Final Drainage Report

Overlook at Homestead Filing No. 1 El Paso County, Colorado

PCD Filing No.: SF2425

Prepared: November 6, 2024

OVERLOOK FILING NO. 1
 EL PASO COUNTY, COLORADO
 CONSTRUCTION DOCUMENTS
PROPOSED DRAINAGE MAP

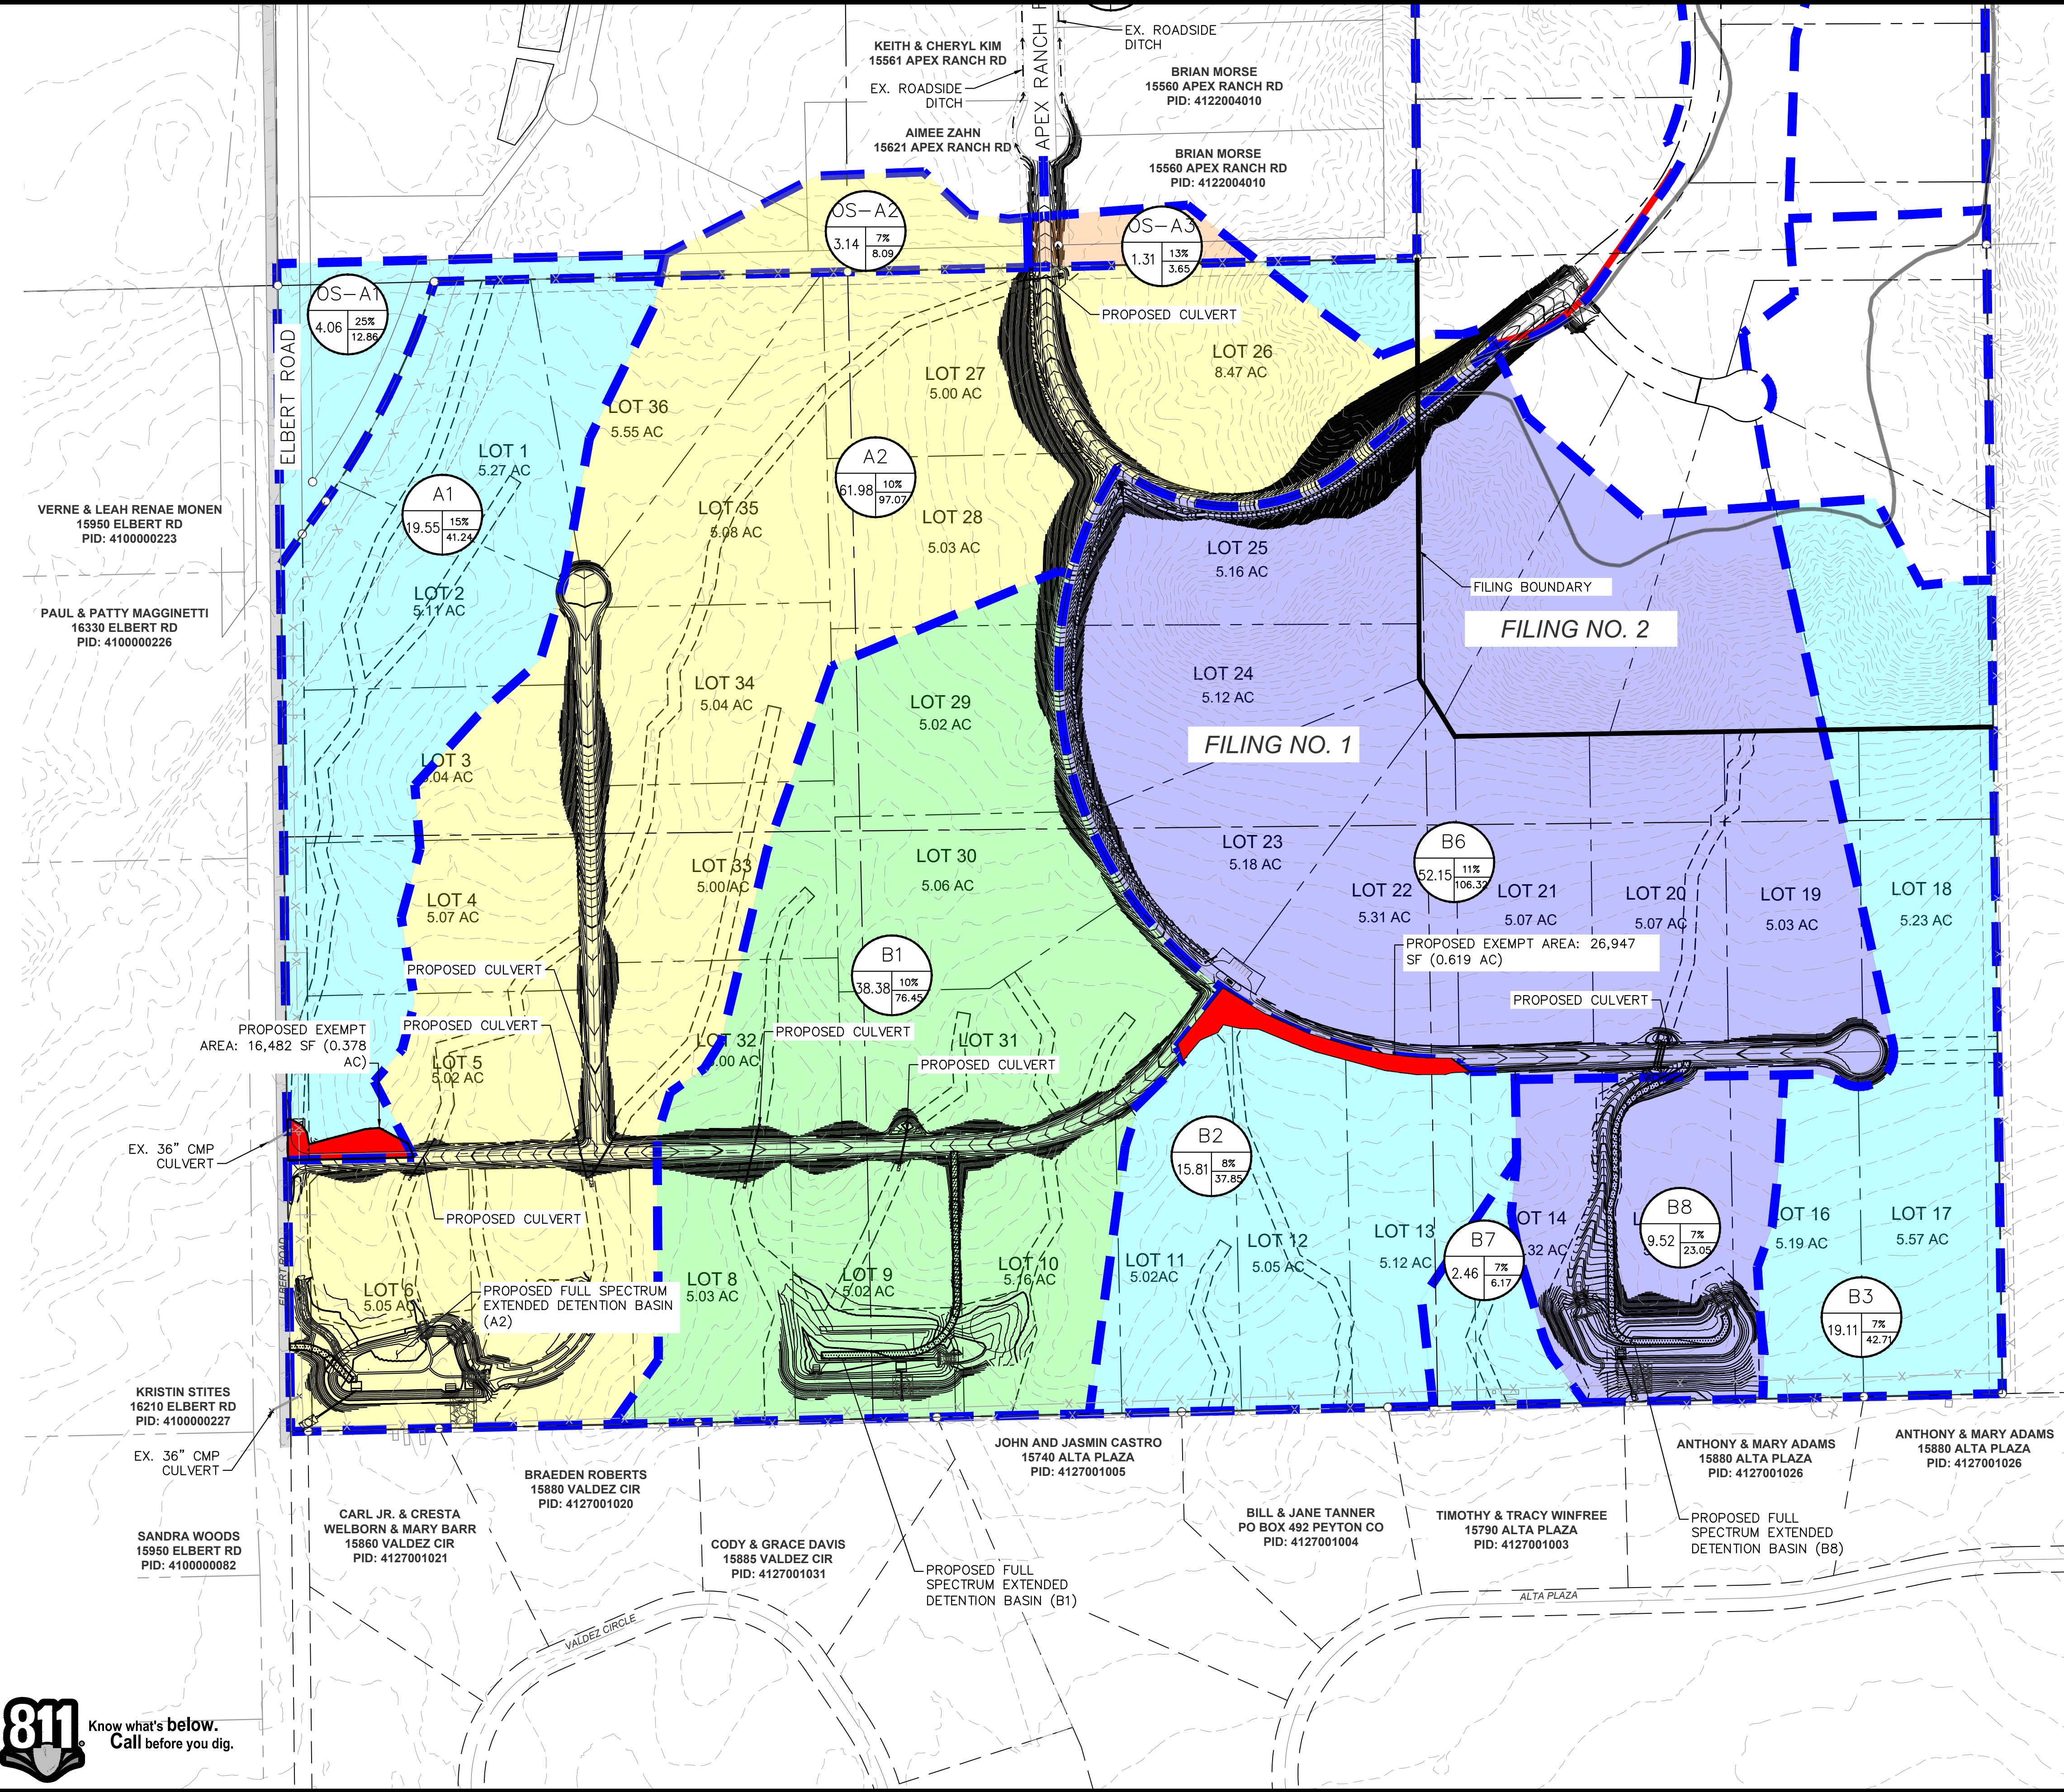
comments have been provided on the calcs for the roadside ditch of Saloon drive
